**21-COA-0228**  
**2347 Frankfort Ave.**

**Clifton Architectural Review Committee**  
**Public Hearing**

**Kat Groskreutz, Historic Preservation Specialist**  
**October 20, 2021**

# Site Photos

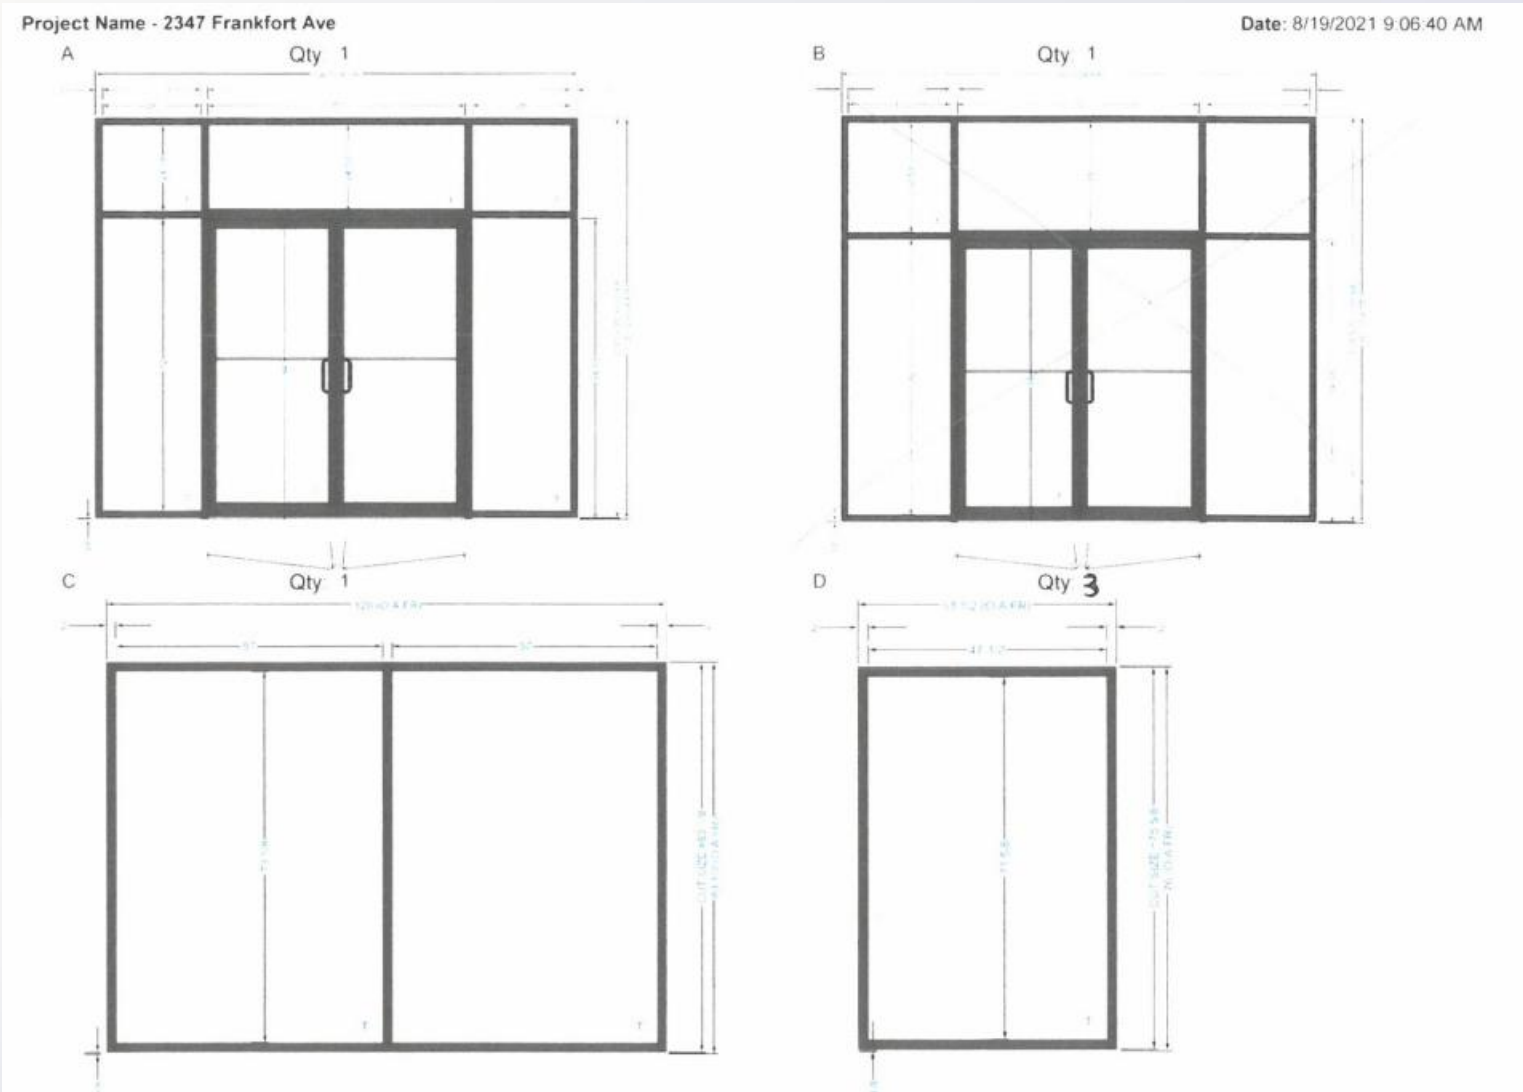
- The proposed window replacement somewhat meets the Clifton design guidelines for **Window and Storefront**:
  - Staff determined the windows are severely deteriorated and appropriate for replacement
  - Shortened historic opening to the left will be reopened
  - Three historic openings on right will be maintained
  - Glass in the 16-lite metal windows is frosted and not appropriate for a commercial retail building
  - Staff finds metal replacement windows in all four window openings appropriate as the historic windows are metal rather than the non-historic wood windows
  - Metal windows will help retain the historic 1920s look of the building

- The proposed window replacement somewhat meets the Clifton design guidelines for **Window and Storefront**:
  - Only partially meets guidelines SF1, SF6, SF7, SF17, SF20, W4 and W8 and does not meet W2
  - Historic 16-lite windows are character defining; some of only remaining historic fabric on the building
  - Staff suggests the applicant source windows through a company like Quaker Windows that can recreate commercial windows in a similar metal framed style as existing, but still provide energy efficiency
  - Staff also suggests same type of window be installed in the left opening to help restore the front façade storefront if possible

- Staff recommends the application for a Certificate of Appropriateness be **approved with the following conditions:**
  1. The applicant shall install replacement windows that match the existing window pane configurations and muntin proportions. Staff shall review window specifications for these openings prior to their ordering and installation.
  2. The historic window and door openings shall be retained and not blocked in or enlarged to accommodate existing or stock windows and doors.

3. The glass shall be clear and shall not have a tinted, reflective, or insulating film. If a low-E coating is used, it shall be clear.
4. Thermal glazing windows that have muntins in accordance with W2 shall have such muntins permanently applied and may also incorporate internal dividers between the glass panes.
5. All other required permits and approvals shall be acquired prior to construction.
6. If the design or materials change, Staff shall be contacted for review and approval.
